<b>DOCKETED</b>	
<b>Docket Number:</b>	23-OPT-01
<b>Project Title:</b>	Fountain Wind Project
<b>TN #:</b>	248330-2
<b>Document Title:</b>	Project Refinement Memo September 2021
<b>Description:</b>	N/A
<b>Filer:</b>	Caitlin Barns
<b>Organization:</b>	Stantec Consulting Services, Inc.
<b>Submitter Role:</b>	Applicant Consultant
<b>Submission Date:</b>	1/5/2023 10:09:40 AM
<b>Docketed Date:</b>	1/5/2023

To:	Shasta County Planning Department and Board of Supervisors	From:	Stantec Environmental Services
File:	Fountain Wind Project	Date:	September 24, 2021

**Reference: Analyses of Refinements to the Proposed Project Design Since Circulation of the Final Environmental Impact Report**

Title  
**30-Mile Radius Viewshed Turbine Blade  
Tip – Proposed / Refined Comparative**

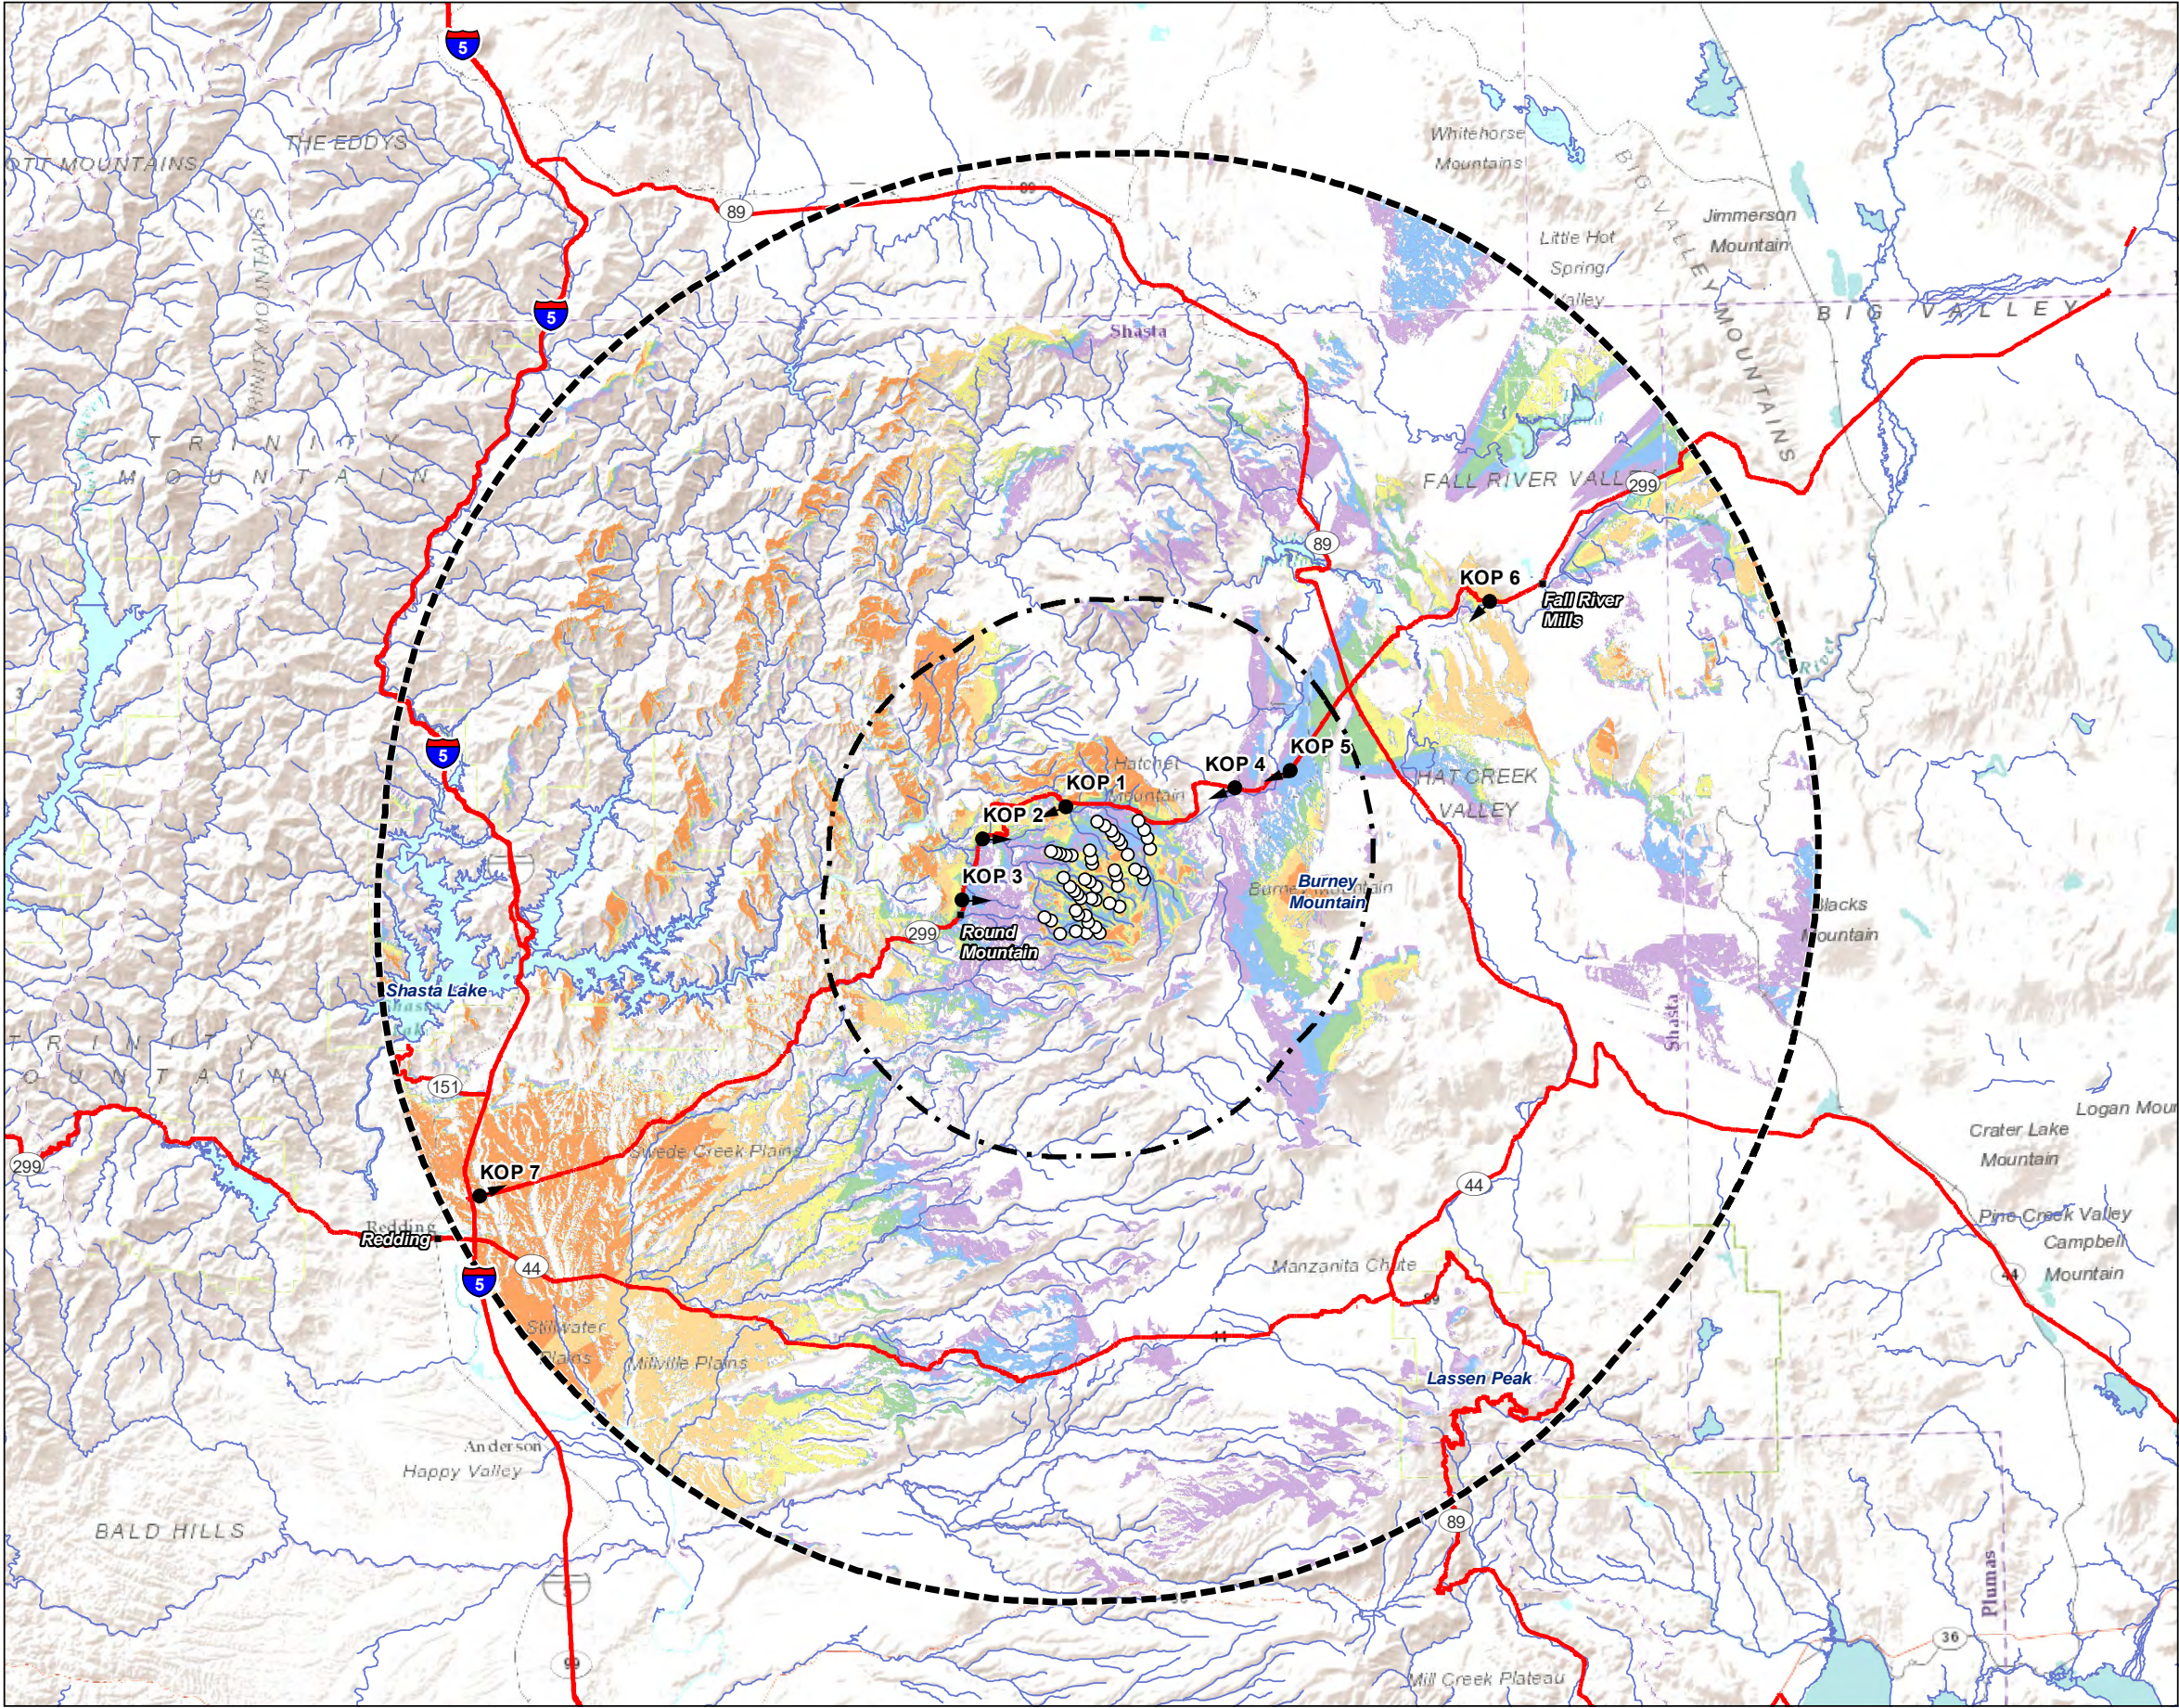
The reduction in number of turbines from 72 to 48, and the associated smaller project footprint, would reduce the total area within which the project would be potentially visible as summarized in Table 5 and shown in the refined viewshed documents (Figures 5c through 5g). Figure 5c shows a simple comparison between the two project layouts, indicating the areas that were identified as having visibility of the project as proposed but where there would not be visibility of the project as refined.

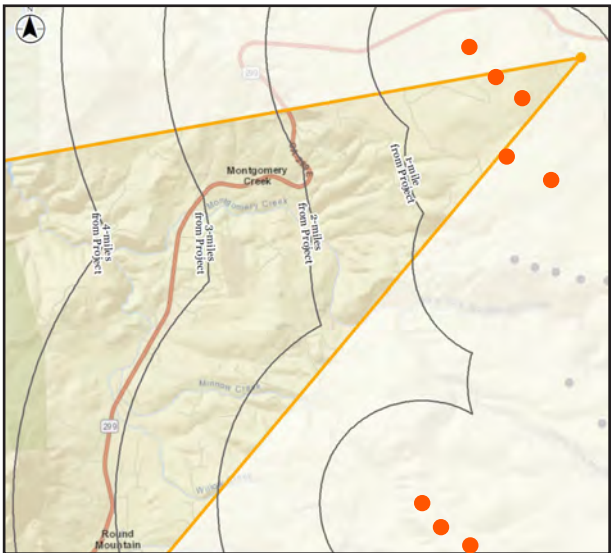
- **KOP 1: Fountain Fire Overlook** – With the refined design, turbines originally proposed to be located west of the Fountain Fire Overlook and near the Moose Camp residential area would not be installed. Therefore, these turbines would no longer be visible from KOP 1 (Figure 6-1).

A: View from KOP 1 with 72-turbine layout simulated as evaluated in the FEIR. Proposed turbines would be visible just under one mile away. This view was evaluated as an approximation of Project visibility from nearby Moose Camp.

B: There would be no turbines visible from KOP 1 with the 48-turbine layout.

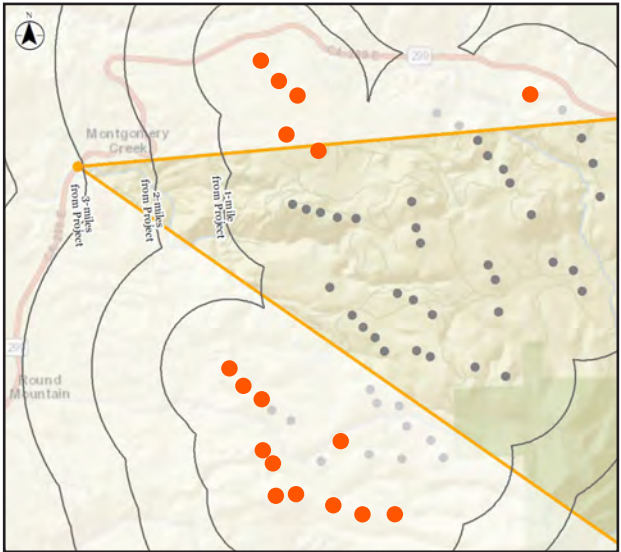
- **KOP 2: Montgomery Creek** – One turbine, along the left edge of the view, would be removed with the refined design. The other nine turbines would remain visible but lower in profile along the ridgeline in the center of the view (Figure 6-2).

A: View from KOP 2 with 72-turbine layout simulated as evaluated in the FEIR. Proposed turbines would be most visible in the left half of the view, between 3 and 5 miles away.

B: With the 48-turbine layout, one turbine would be removed from the left edge of this view. Other turbines would remain but would appear lower in profile along the ridgeline in the center of the view.

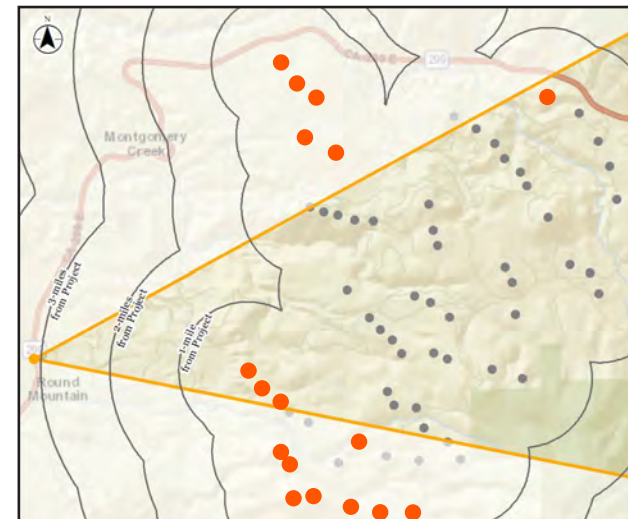
- **KOP 3: Round Mountain** – The three nearest visible turbines in the view evaluated in the Draft and Final EIR (in the right of the view, visible from between 3 and 3.6 miles away) would be removed under the refined design and another would drop below the ridgeline. The nine turbines remaining visible would appear from this distance as lower in profile along ridgelines due to shorter overall heights, though the larger rotor diameters portrayed in the simulations would make them slightly more prominent (Figure 6-3).

A: View from KOP 3 with 72-turbine layout simulated as evaluated in the FEIR. Proposed turbines would be visible between 3 and 6 miles away.

B: With the 48-turbine layout, the three nearest turbines visible in the right of the view evaluated in the FEIR would be removed. The height of other remaining turbines would appear lower along the ridgelines, though their increased rotor diameters would make them slightly more prominent.

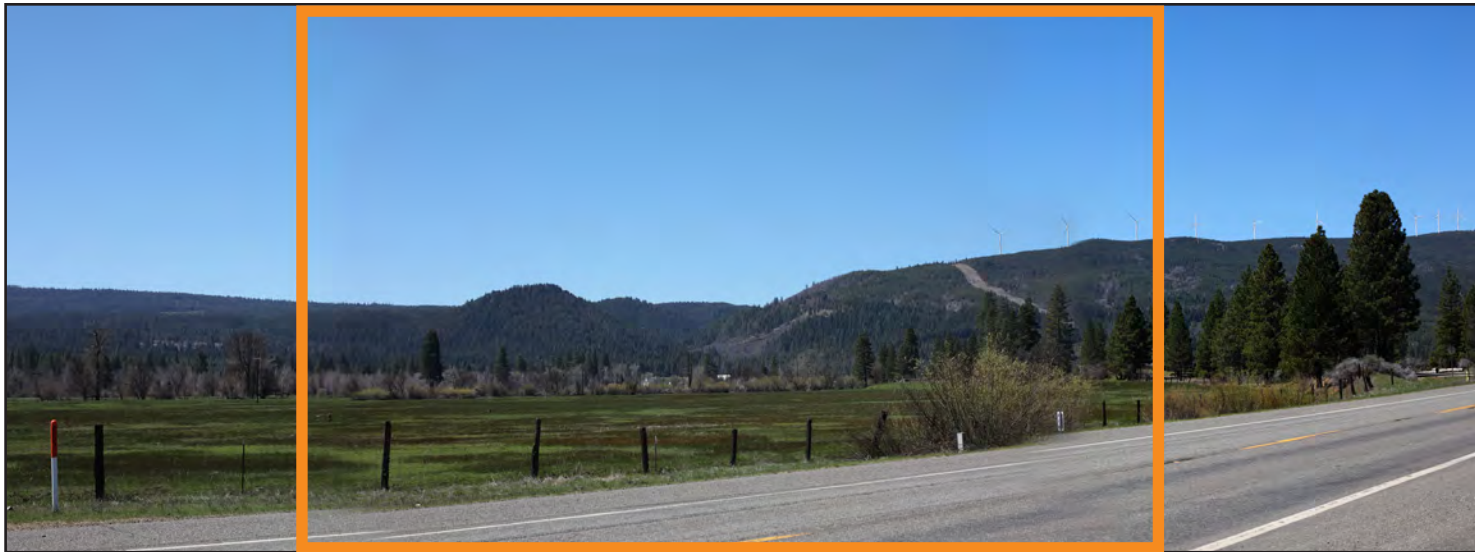
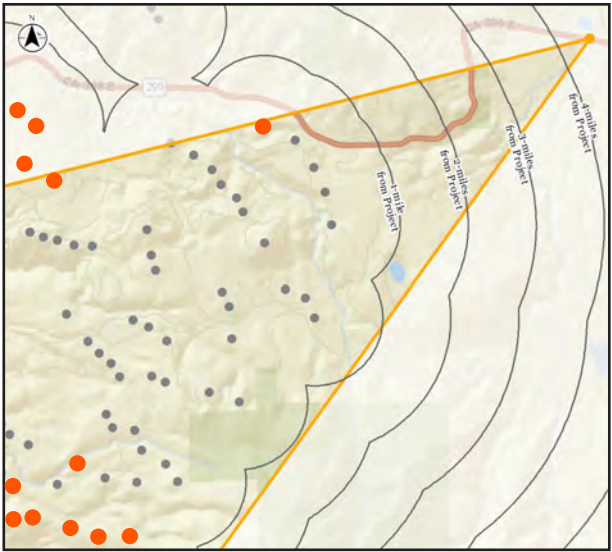
- **KOP 4: SR 299 at Tamarack Road** – Of the two project turbines visible from this location under the 72-turbine layout, one would be removed and the other would appear slightly lower in profile (Figure 6-4).

A: View from KOP 4 with 72-turbine layout simulated as evaluated in the FEIR. Two Project turbines would be visible between 4 and 6 miles away, in the center of the view.

B: With the 48-turbine layout, the nearer of the two Project turbines would be removed and the other would appear slightly shorter.

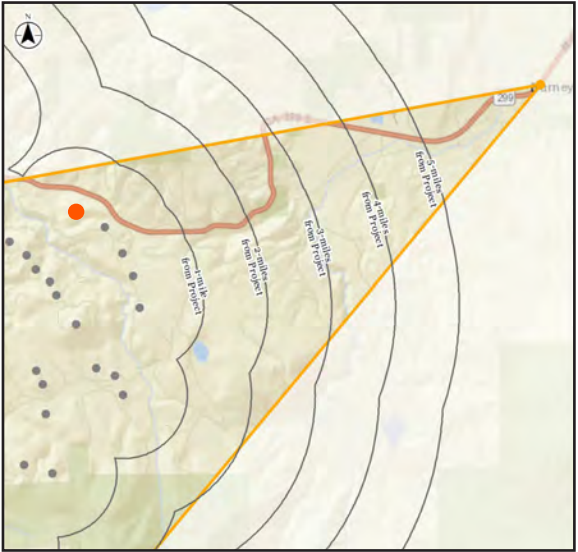
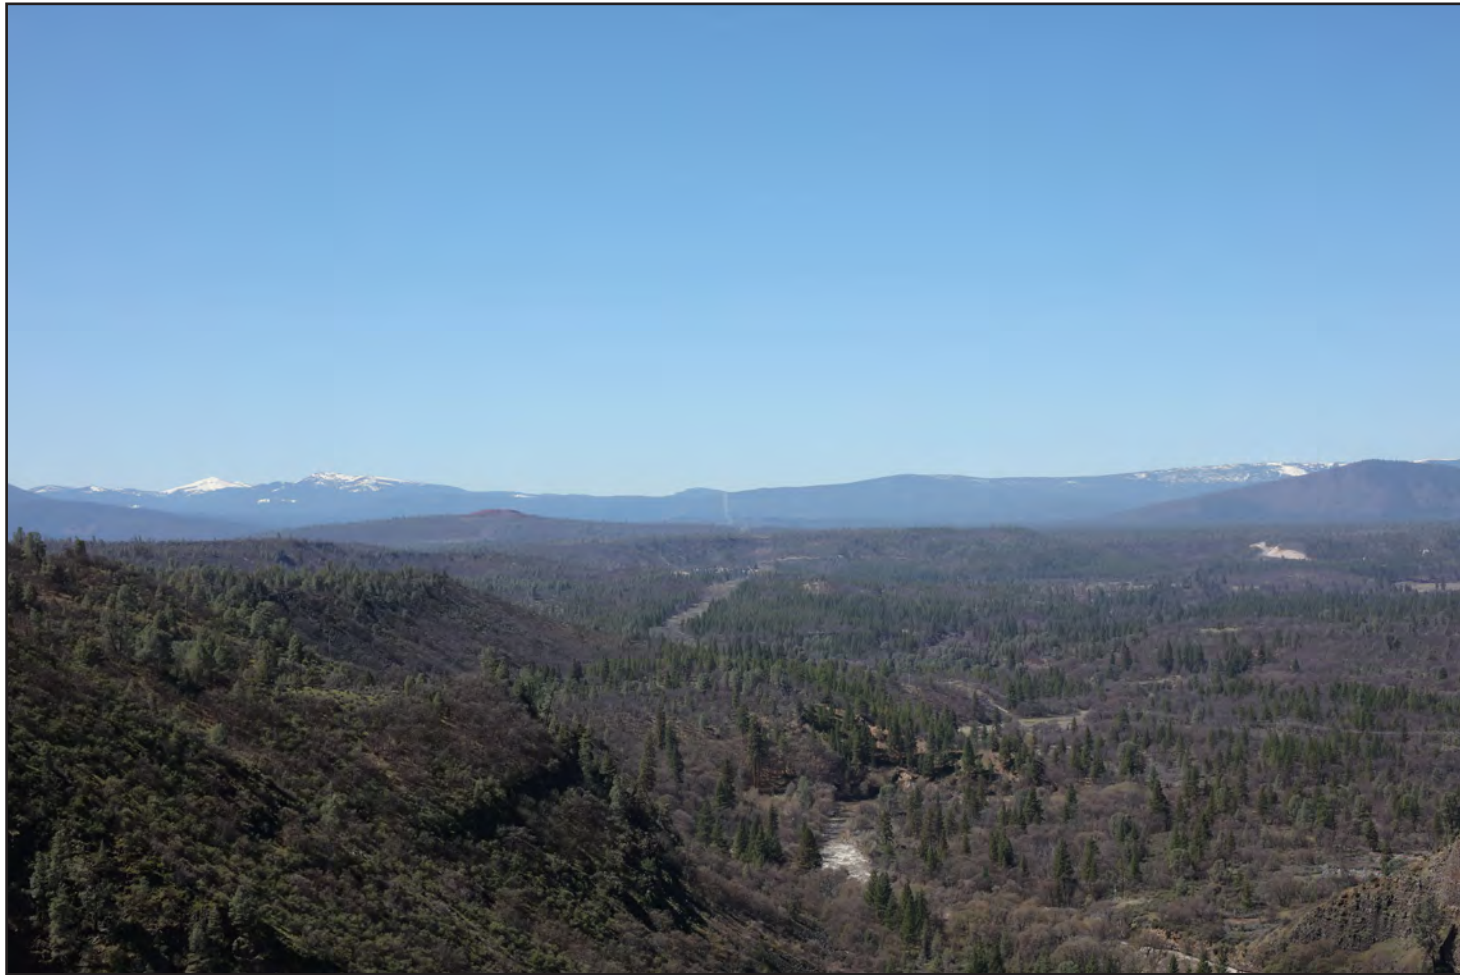
- **KOP 5: Burney** – Seven turbines visible along the ridgeline between 7 and 10 miles away (compared with eight visible with the 72-turbine layout) would appear slightly lower in profile (Figure 6-5).

A: View from KOP 5 with 72-turbine layout simulated as evaluated in the FEIR. The Project turbines in the center of the view would be visible between 7 and 10 miles away and appear to the left of the existing Hatchet Ridge turbines.

B: With the 48-turbine layout, Project turbines would remain in view but appear lower in profile along the ridgeline.
